GM SERVICE AND PARTS OPERATIONS
DCS 2196
URGENT - DISTRIBUTE IMMEDIATELY

SUBJECT: 08157 – Noncompliance Recall
Instrument Panel Storage Bin Door Compliance - Add Reinforcement Bracket

MODELS: 2006-2008 Chevrolet HHR

SUBJECT: Instrument Panel Storage Bin Door Compliance – Add Reinforcement Bracket

22002517

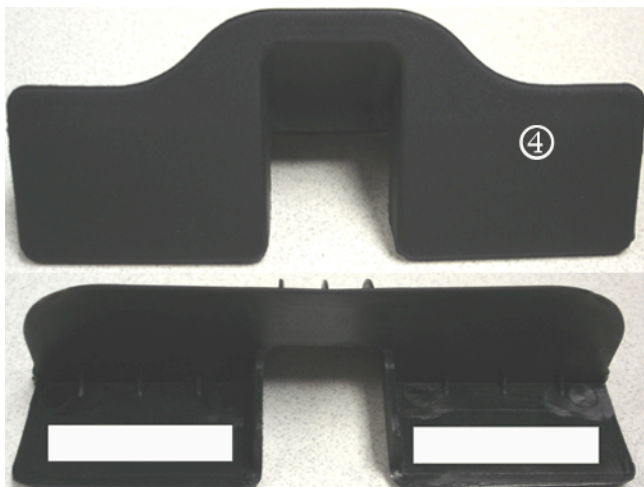
1. Locate and open the instrument panel storage bin (1).
2. Locate the instrument panel storage bin latch (2).

3. Determine if the storage bin is a first (A) or second (B) design storage bin. The second design storage bin (B) includes latch pin holes (3) on the left and right side of the latch.
 - If the vehicle is equipped with a first design storage bin (A), installing a reinforcement latch plate bracket *IS* required. Proceed to Step 4.
 - If the vehicle is equipped with a second design storage bin (B), installing a reinforcement latch plate bracket is *NOT* required. No further action is required.
